Access Compliance Report

Public Rights-of-Way

(Curb Ramps)

Intersection ID: 6041	Main Street: E_MCCULLOUGH_DR	Cross Street: KEN_HOFFMAN_DR	Location:	NE
ADA ID: 7545E4BD768F	Ramp Type: Perp	Initial Pass/Fail: Fail	Overall Compliance: No	Severity Score: 25
Codes/Mitigation Info/Possible Solution		Field Measurements/Component Compliance

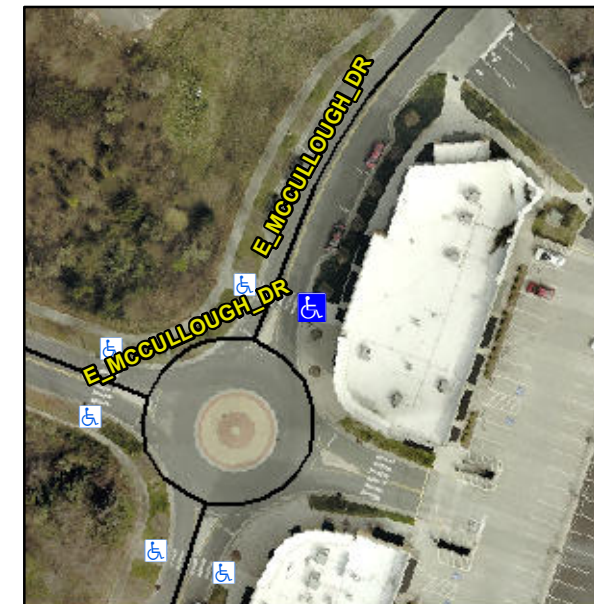
Not Found, R304.2.2

Compliance	Description	Data	Compliance	Description	Data
N/A	Ramp Length (in)	180.0	No	Ramp Slope (%)	16.3
Yes	Ramp Width (in)	73.0	Yes	Ramp XSlope (%)	0.3
N/A	Flare Type LT	N/A	N/A	Flare Type RT	N/A
N/A	Flare Slope LT (%)	N/A	N/A	Flare Slope RT (%)	N/A
N/A	Flare Traversable LT?	N/A	N/A	Flare Traversable RT?	N/A
N/A	Landing Length (in)	N/A	N/A	DWS Provided?	N/A
N/A	Landing Width (in)	N/A	N/A	DWS Contrast?	N/A
N/A	Landing Slope (%)	N/A	N/A	DWS Length (in)	N/A
N/A	Landing X Slope (%)	N/A	N/A	DWS Full Width?	N/A
N/A	Landing Curb? (Y/N)	N/A	N/A	DWS Offset (in)	N/A
N/A	Shared Landing?	N/A			
N/A	Gutter Ponding?	N/A	N/A	Gutter Slope (%)	N/A
N/A	Gutter Lip Ht (in)	N/A	N/A	Gutter X Slope (%)	N/A
N/A	Painted X Walk1?	Yes	N/A	Painted X Walk2?	N/A
	X Walk 1 Direction	To NW		X Walk 2 Direction	N/A
N/A	X Walk 1 Width (in)	118.0	N/A	X Walk 2 Width (in)	N/A
	X Walk 1 Slope (%)	1.7		X Walk 2 Slope (%)	N/A
	X Walk 1 X Slope (%)	0.5		X Walk 2 X Slope (%)	N/A

Remove & Replace Entire Ramp.
